SUBJECT: Addendum to Third Work Plan

Subject: Addendum to Third Workplan, Wente Brothers Winery, 5565 Tesla Road, Livermore, CA

Figure 4: Site map showing approximate locations of proposed CPT, MIP and groundwater sampling boreholes.

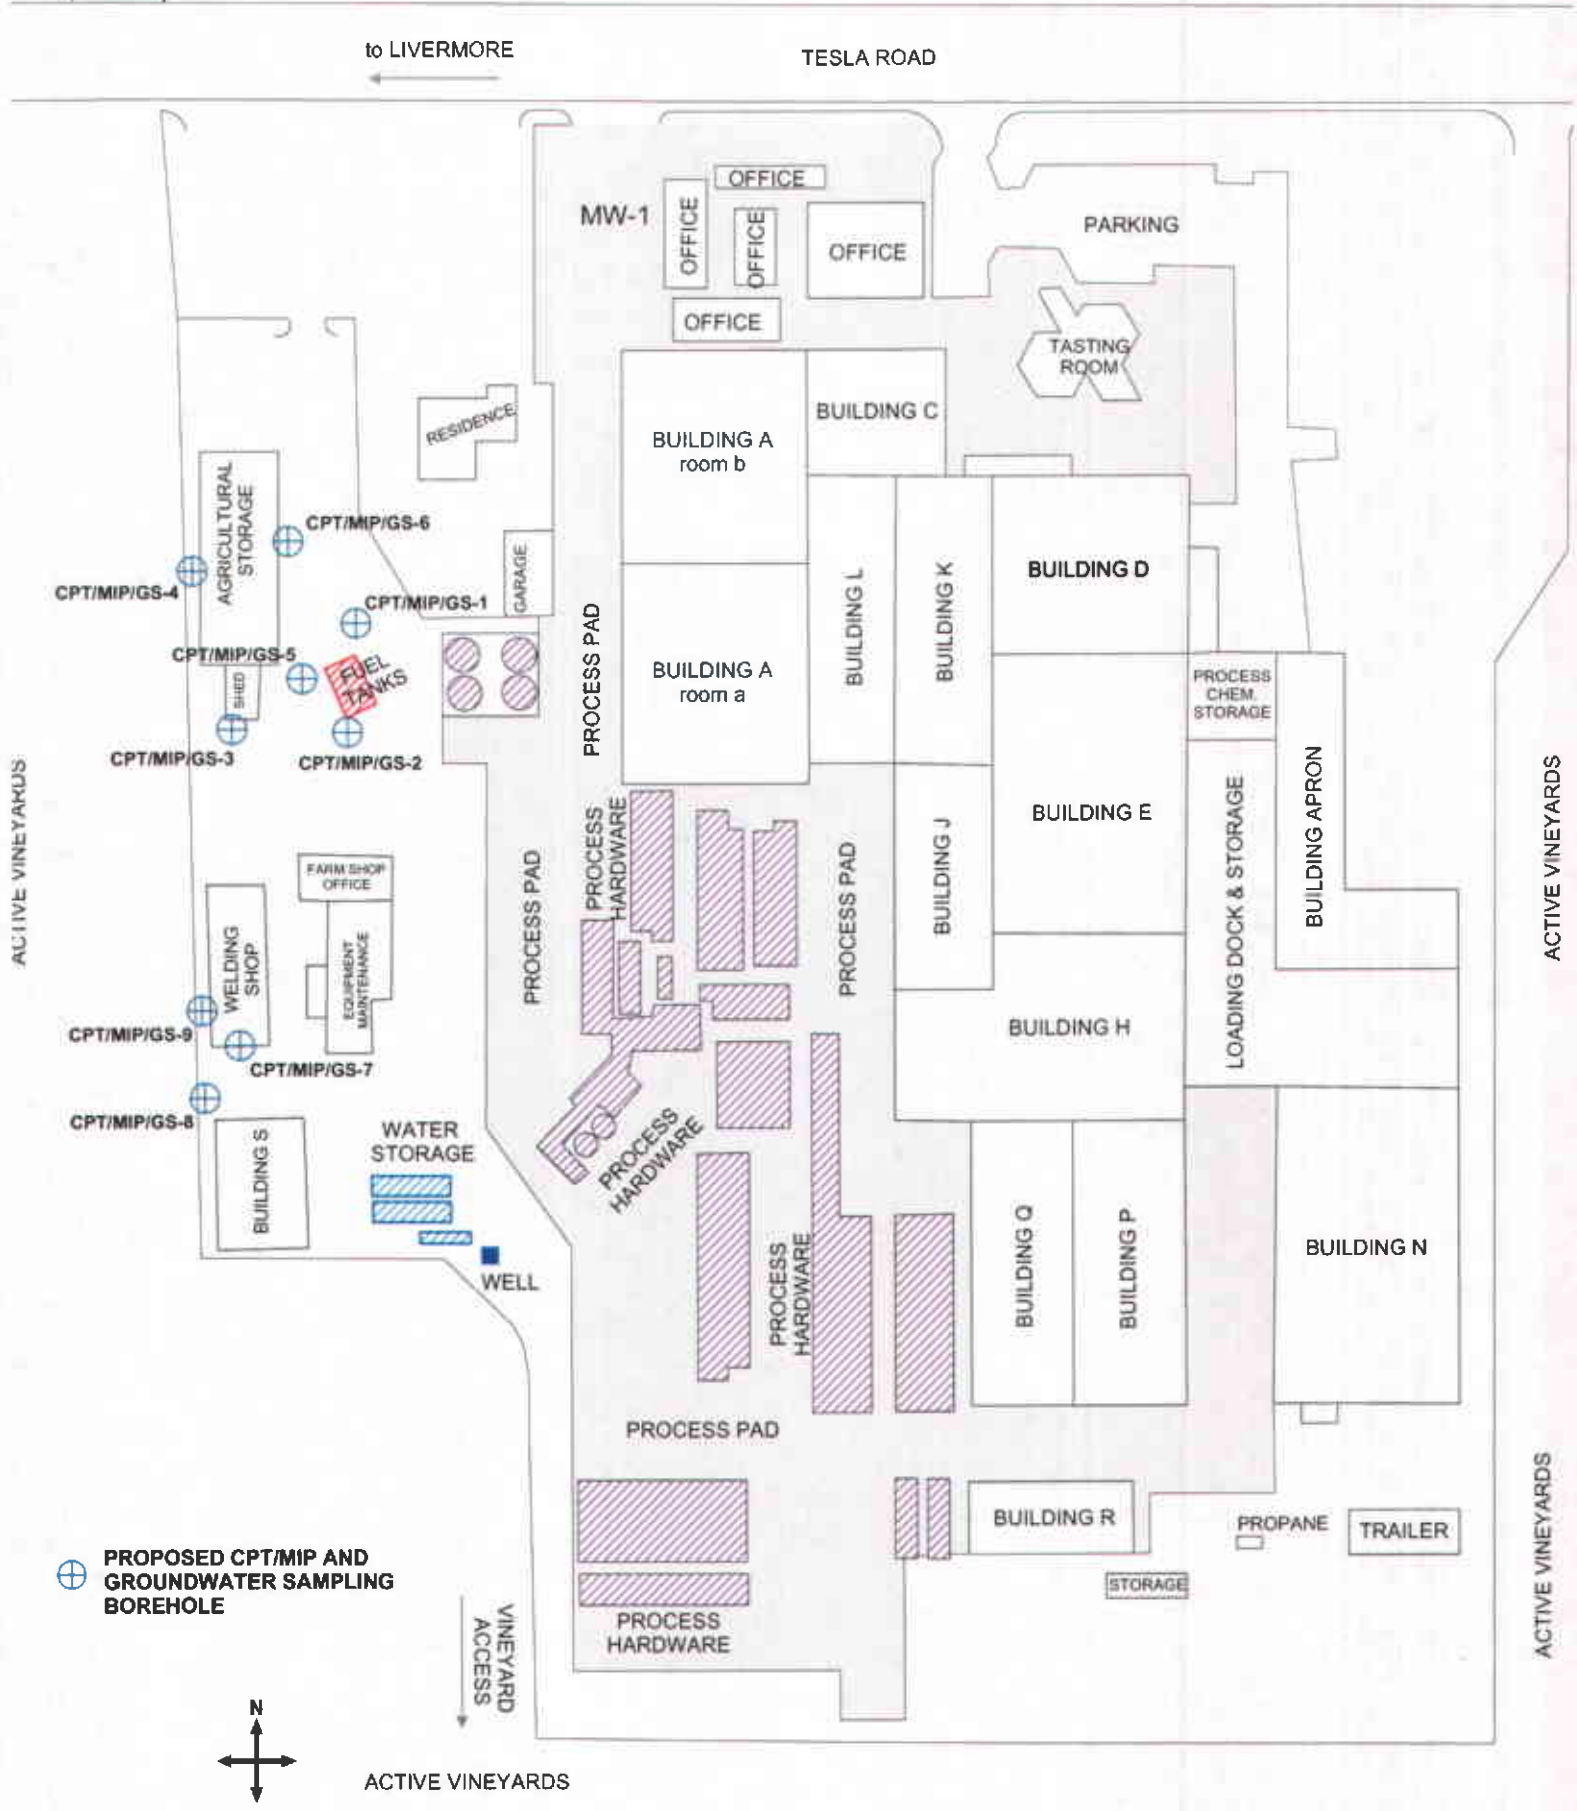
Finally, per your request, the attached map shows the proposed locations of the CPT/MIP boreholes. As we discussed, the proposed locations are based on the assumed groundwater flow direction per the previous consultant's report. The locations may change depending on the results from the Phase I investigation.
